SERVICE BULLETIN

N° 189-269

ATA 30 – STA5700 INSPECTION OF WATER DRAIN FLEXIBLE TUBINGS

Figure 3

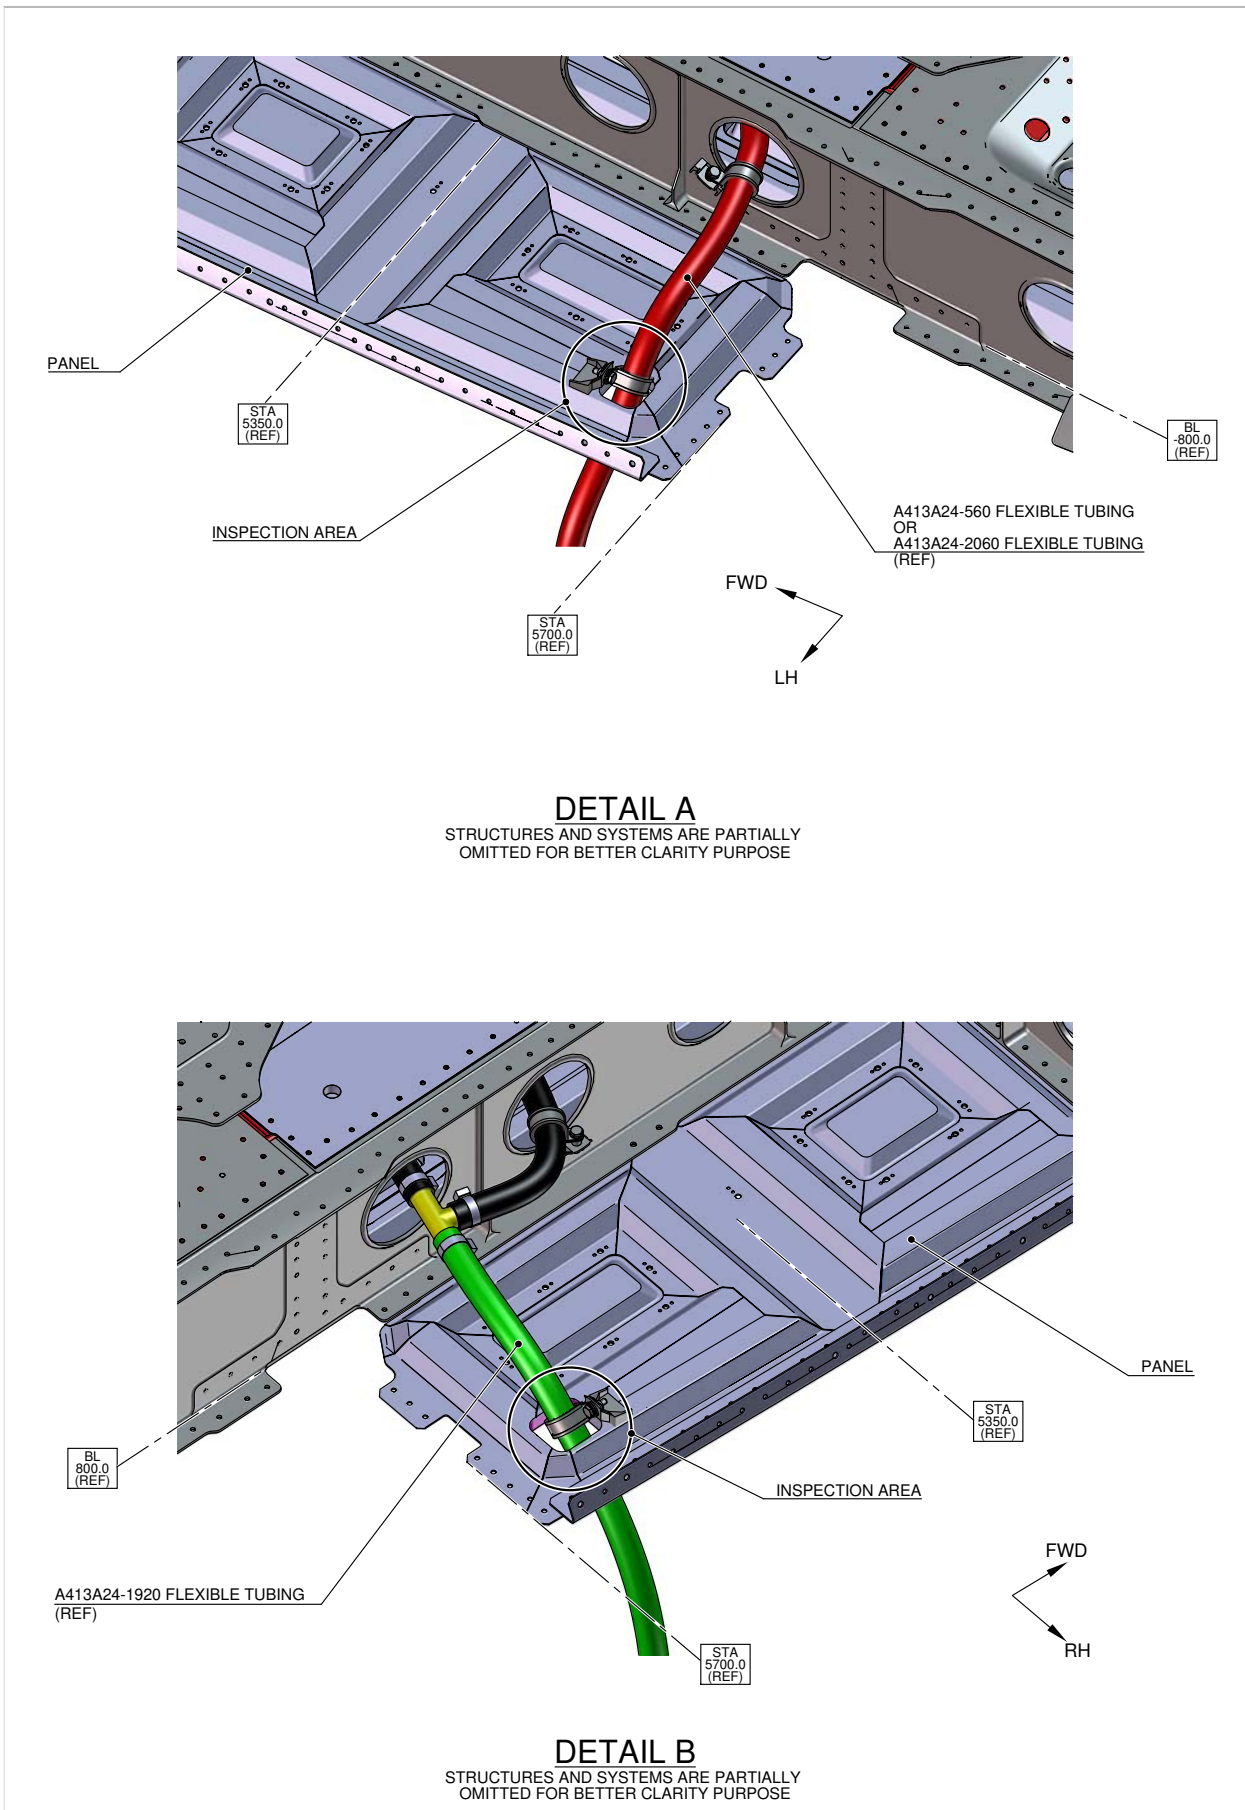
Ref. to Figure 3 Detail A to inspect the flexible tubing on LH side of the helicopter and to Figure 3 Detail B to inspect the flexible tubing on RH side of the helicopter.

- 4. With reference to Figures 3, perform a visual inspection on the indicated areas as follow:
 - 4.1 With reference to Figure 3 Detail A or Detail B, check any interference between the flexible tubing and the structure panel. If necessary, use the sourcelight.
 - 4.2 If any interference is found, check for cracks and sliding wear that may have occurred on the flexible tubing, otherwise skip to step 6.
 - 4.3 If cracks or sliding wear are found on the flexible tubing, proceed with Part II of this Service Bulletin to replace it and proceed to step 5.

Figure 4

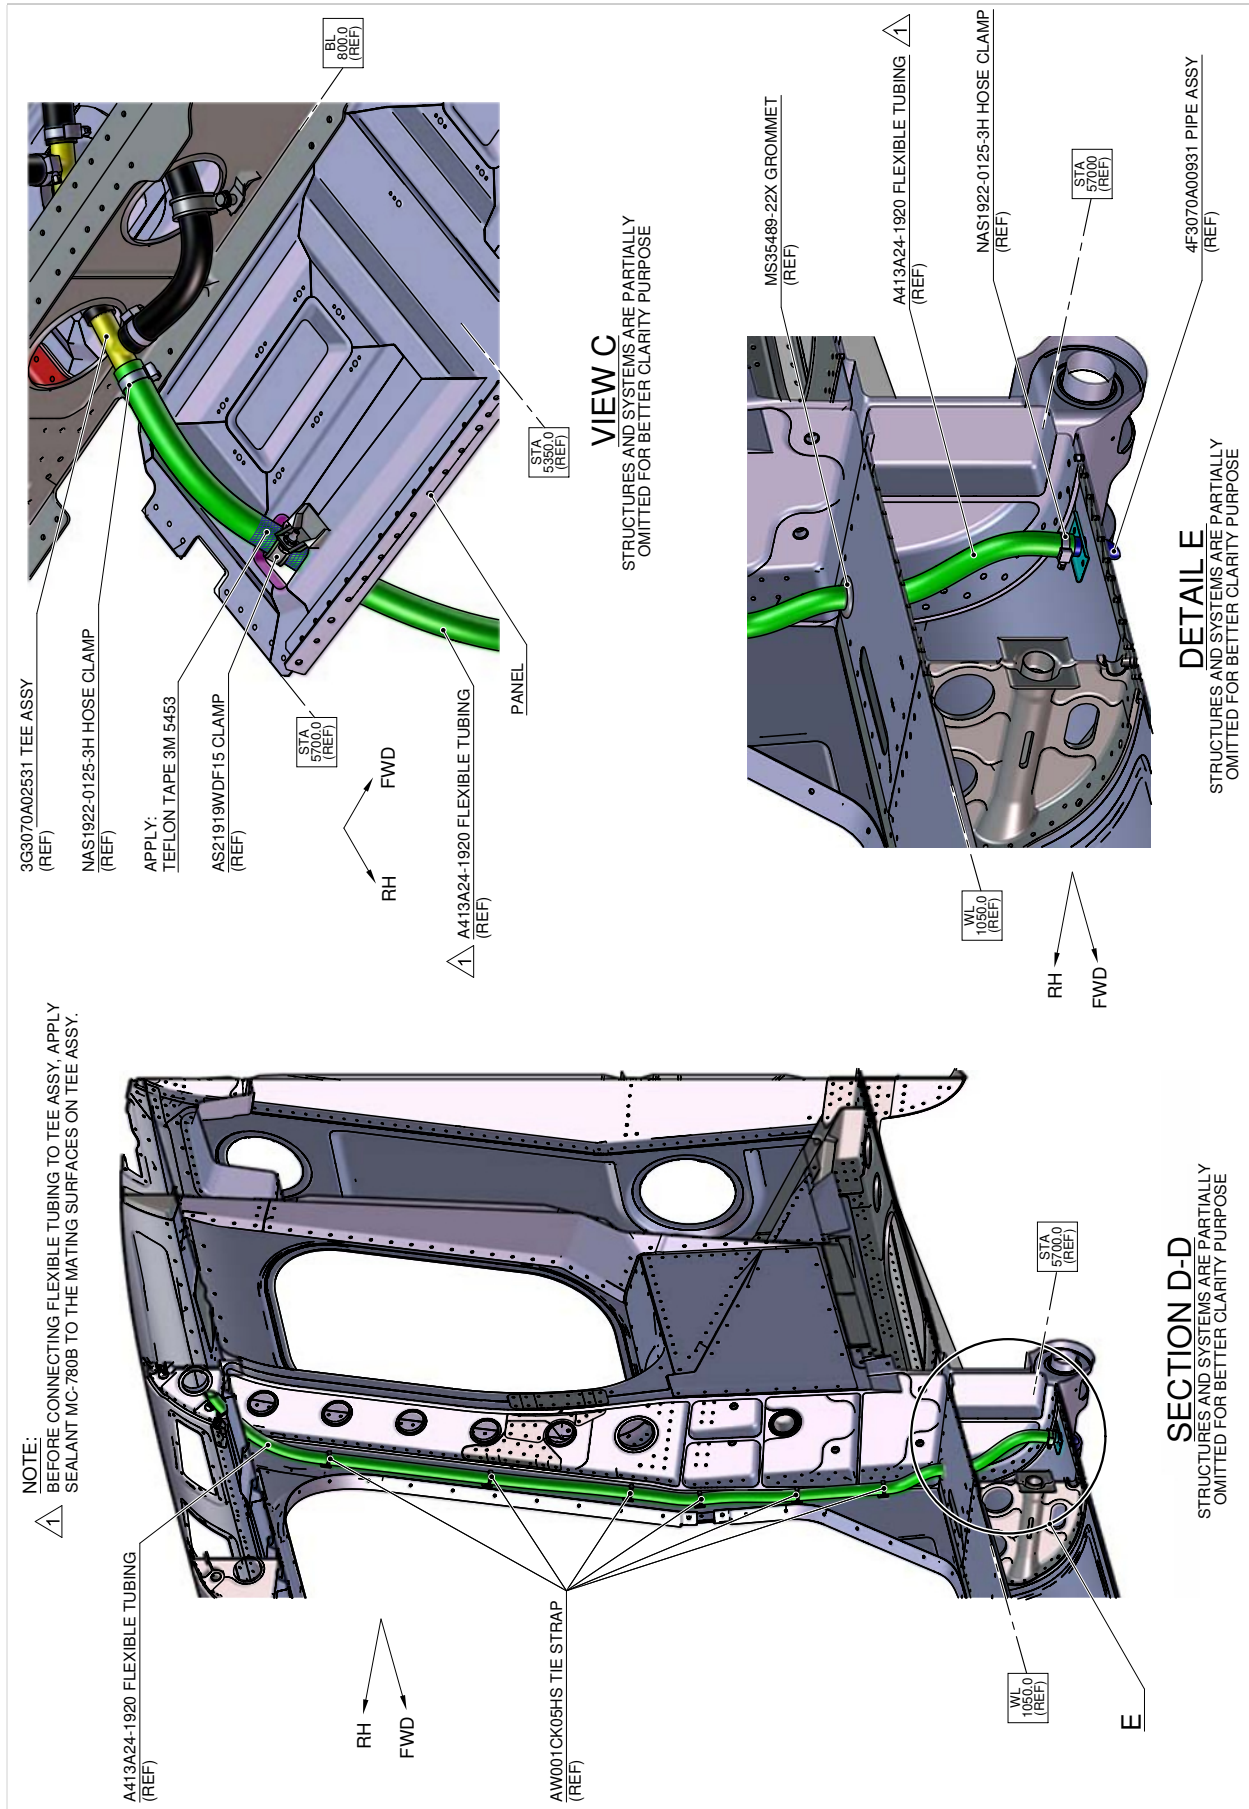
1. With reference to Figure 4, if it is necessary replace the damaged flexible tubing P/N A413A24-1920 with new one as described in the following procedure:
 - 1.1 In accordance with AMP DM 89-A-25-80-00-00A-010A-A and with reference to Figure 4, remove internal linings installed nearby work area at STA5700 as required.
 - 1.2 With reference to Figure 4, remove the damaged flexible tubing P/N A413A24-1920 from the existing drains. Retain the clamps for later reuse.
 - 1.3 With reference to Figure 4, locate the new flexible tubing P/N A413A24-1920 between the existing tee assy P/N 3G3070A02531 and existing pipe assy P/N 4F3070A00931.

- 1.4 With reference to Figure 4 View C, connect flexible tubing P/N A413A24-1920 to existing tee assy P/N 3G3070A02531 by means of previously removed hose clamp P/N NAS1922-0125-3H.
- 1.5 With reference to Figure 4 Detail E, connect flexible tubing P/N A413A24-1920 to existing pipe assy P/N 4F3070A00931 by means of previously removed hose clamp P/N NAS1922-0125-3H.
- 1.6 With reference to Figure 4 View C, apply Teflon tape 3M 5453 (C223) on the flexible tubing in the area where may occur interference between the flexible tubing and the structure panel.
- 1.7 With reference to Figure 4 View C, secure to existing support the flexible tubing P/N A413A24-1920 by means of previously removed clamp and relative hardware.
- 1.8 With reference to Figure 4 Section D-D, secure to existing supports the flexible tubing P/N A413A24-1920 by means of n°6 tie straps AW001CK05HS.

Figure 5

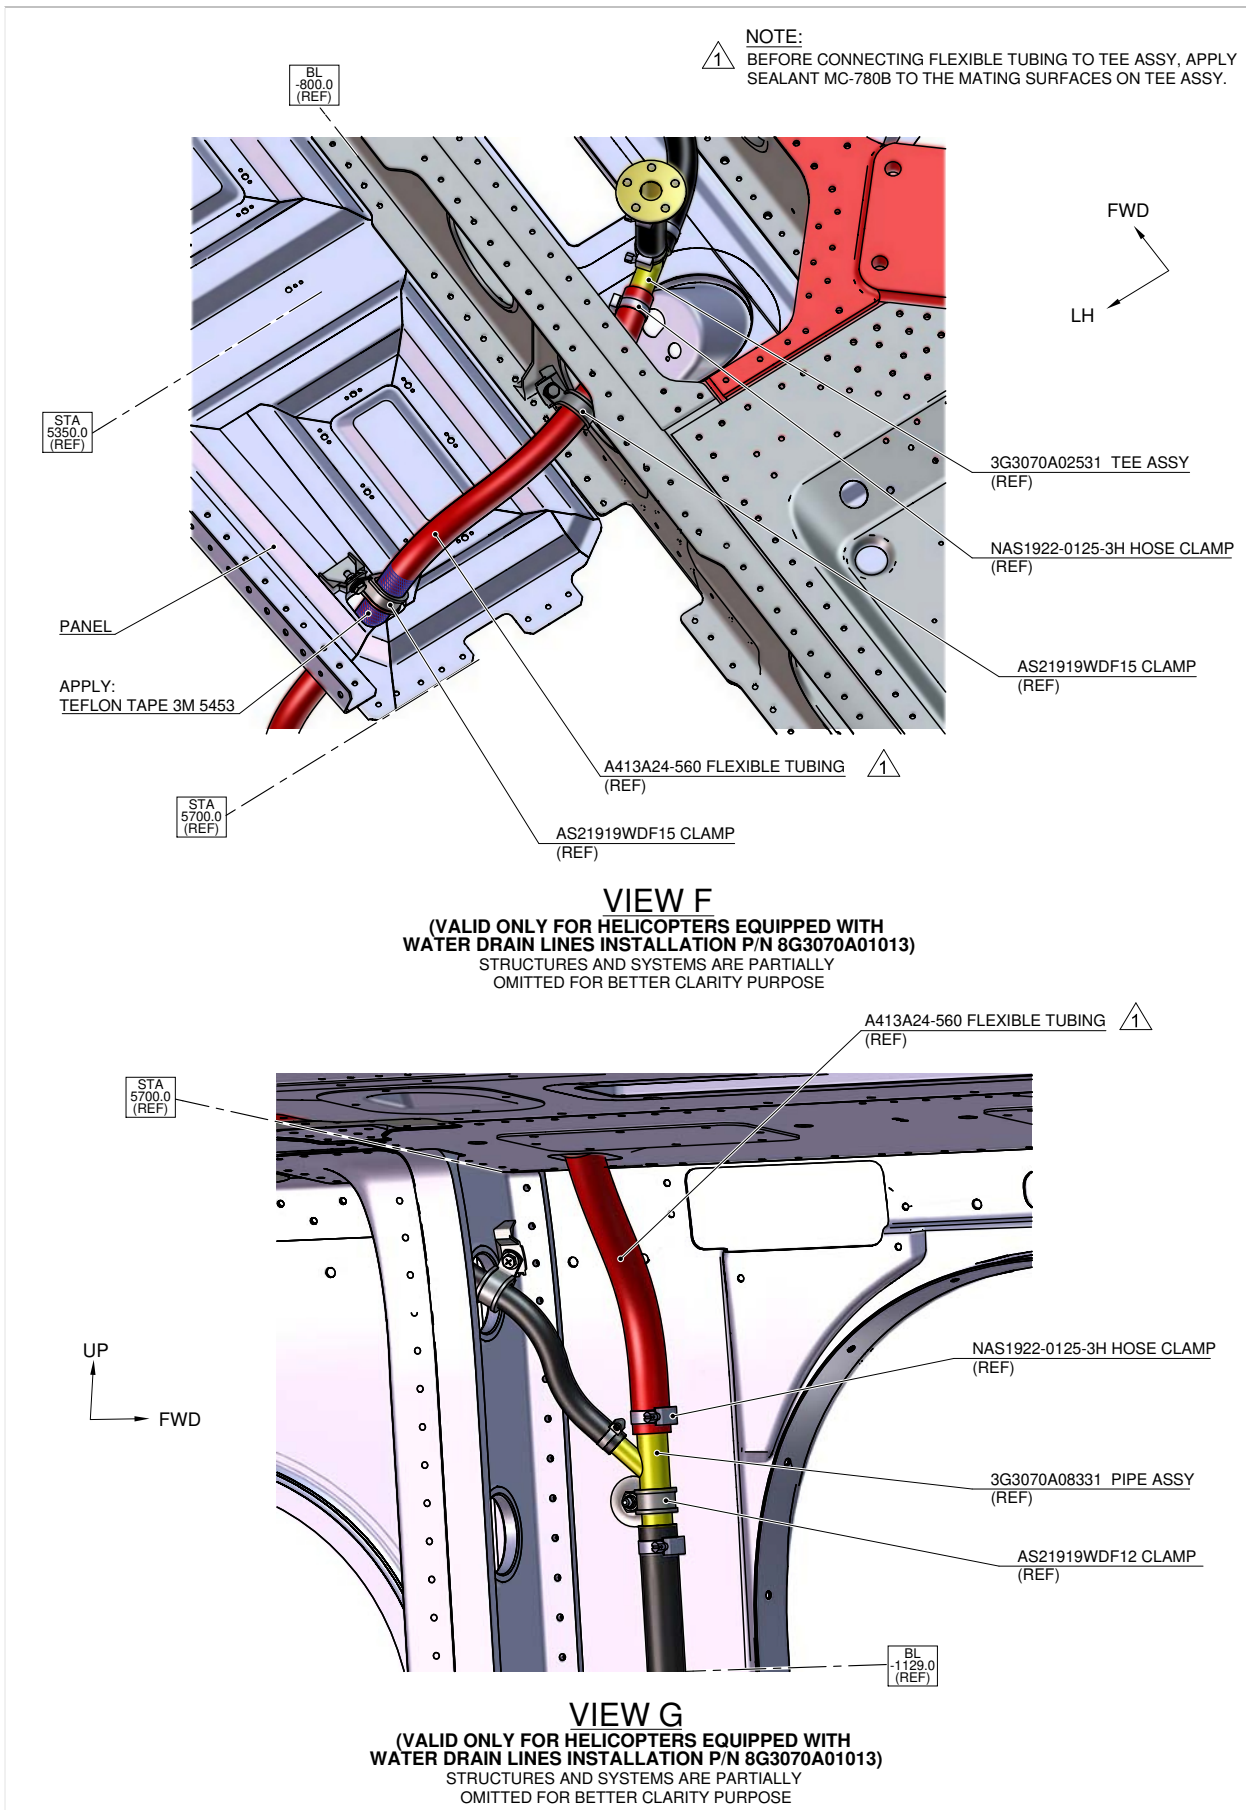
2. With reference to Figure 5, if it is necessary replace the damaged flexible tubing P/N A413A24-560 with new one as described in the following procedure:
 - 2.1 In accordance with AMP DM 89-A-25-80-00-00A-010A-A and with reference to Figure 5, remove internal linings installed nearby work area at STA5700 as required.
 - 2.2 With reference to Figure 5, remove the damaged flexible tubing P/N A413A24-560 from the existing drains. Retain the clamps for later reuse.
 - 2.3 With reference to Figure 5, locate the new flexible tubing P/N A413A24-560 between the existing tee assemblies P/N 3G3070A02531 and P/N 3G3070A08331.

- 2.4 With reference to Figure 5 View F, connect flexible tubing P/N A413A24-560 to existing tee assy P/N 3G3070A02531 by means of previously removed hose clamp P/N NAS1922-0125-3H.
- 2.5 With reference to Figure 5 View G, connect flexible tubing P/N A413A24-560 to existing tee assy P/N 3G3070A08331 by means of previously removed hose clamp P/N NAS1922-0125-3H.
- 2.6 With reference to Figure 5 View F, apply teflon tape 3M 5453 (C223) on the flexible tubing in the area where may occur interference between the flexible tubing and the structure panel.
- 2.7 With reference to Figure 5 View F, secure to existing supports the flexible tubing P/N A413A24-560 by means of previously removed clamps and relative hardware.

Figure 6

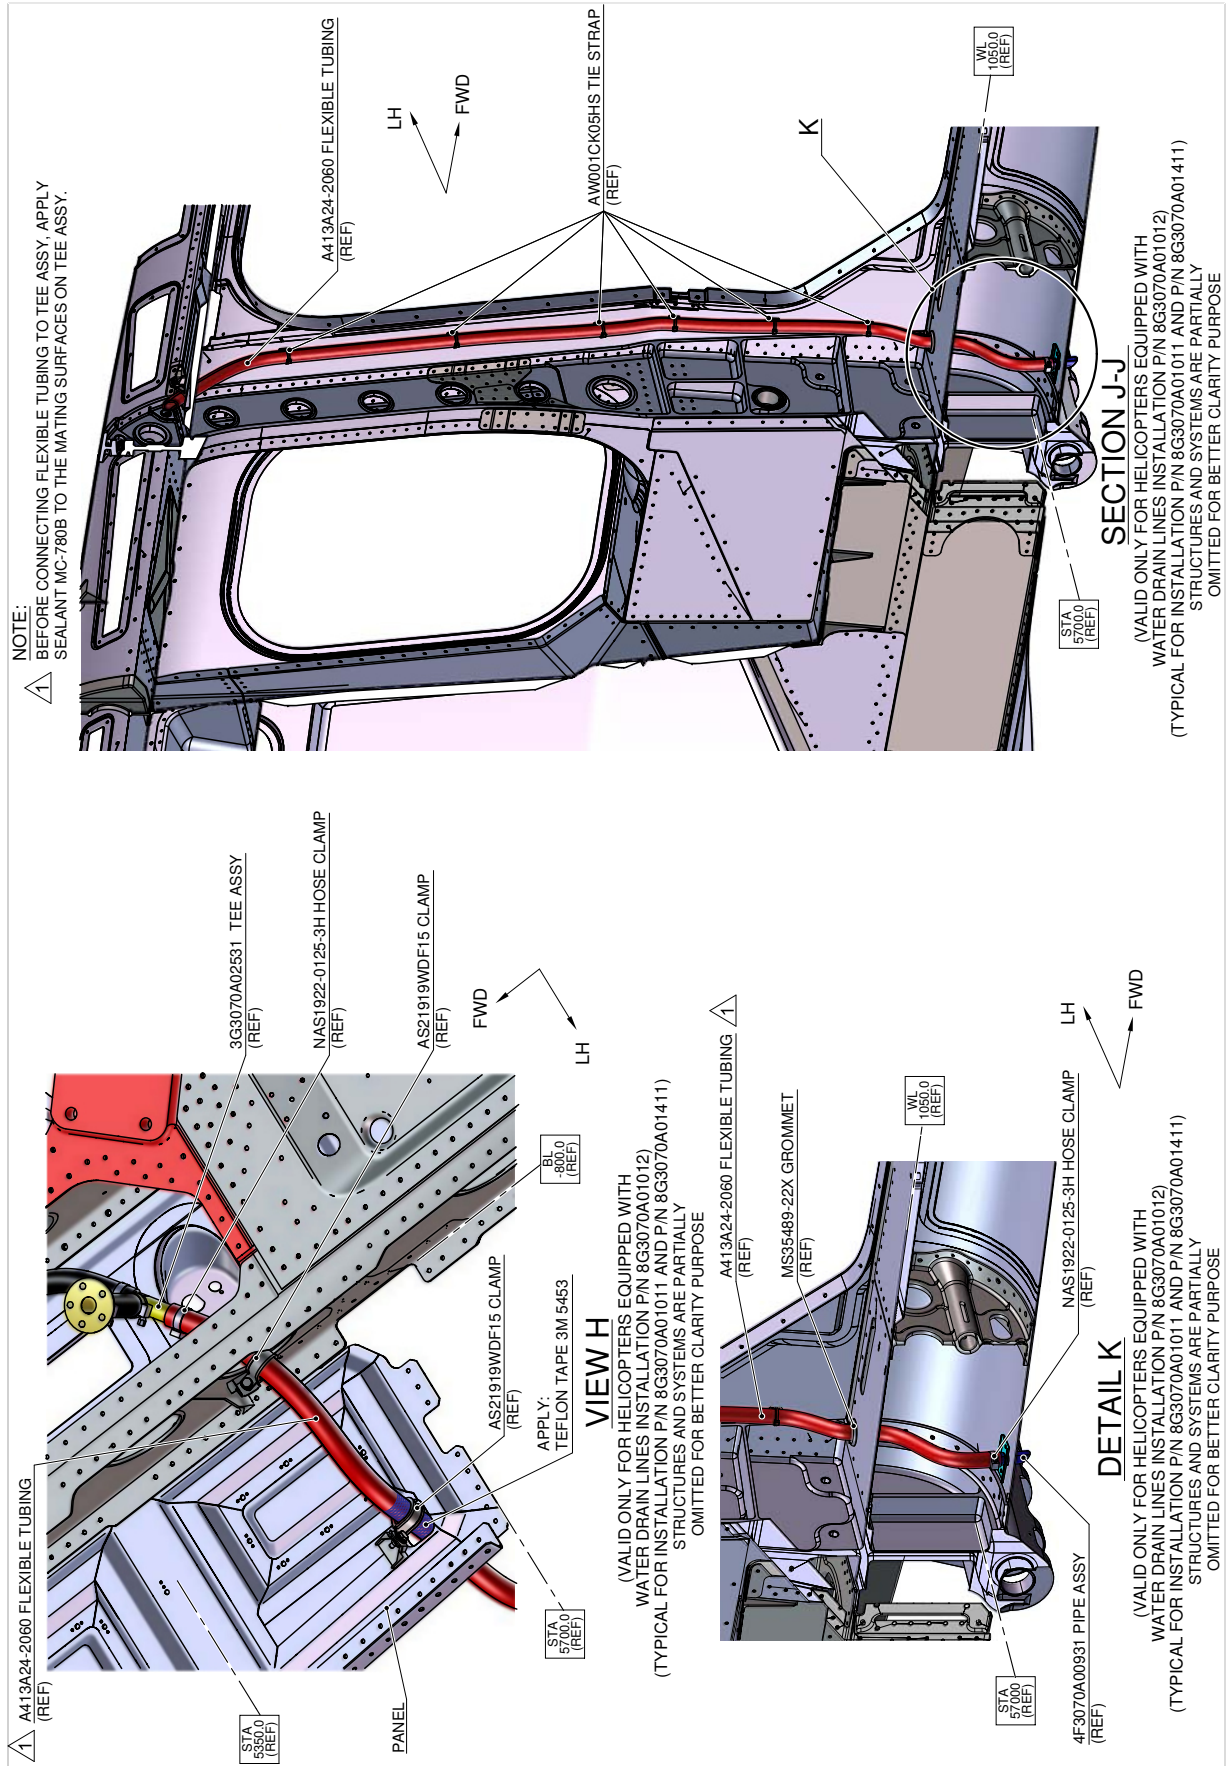
3. With reference to Figure 6, if it is necessary replace the damaged flexible tubing P/N A413A24-2060 with new one as described in the following procedure:

- 3.1 In accordance with AMP DM 89-A-25-80-00-00A-010A-A and with reference to Figure 6, remove internal linings installed nearby work area at STA5700 as required
- 3.2 With reference to Figure 6, remove the damaged flexible tubing P/N A413A24-2060 from the existing drains. Retain the clamps for later reuse.
- 3.3 With reference to Figure 6, locate the new flexible tubing P/N A413A24-2060 between the existing tee assy P/N 3G3070A02531 and existing pipe assy P/N 4F3070A00931.

- 3.4 With reference to Figure 6 View H, connect flexible tubing P/N A413A24-2060 to existing tee assy P/N 3G3070A02531 by means of previously removed hose clamp P/N NAS1922-0125-3H.

- 3.5 With reference to Figure 6 Detail K, connect flexible tubing P/N A413A24-2060 to existing pipe assy P/N 4F3070A00931 by means of previously removed hose clamp P/N NAS1922-0125-3H.

- 3.6 With reference to Figure 6 View H, apply Teflon tape 3M 5453 (C223) on the flexible tubing in the area where may occur interference between the flexible tubing and the structure panel.

- 3.7 With reference to Figure 6 View H, secure to existing support the flexible tubing P/N A413A24-2060 by means of previously removed clamp and relative hardware.

- 3.8 With reference to Figure 6 Section J-J, secure to existing supports the flexible tubing P/N A413A24-2060 by means of n°6 tie straps AW001CK05HS.
4. In accordance with AMP DM 89-A-25-80-00-00A-010A-A and with reference to Figure 4 and Figures 5 or 6, re-install internal linings previously removed.
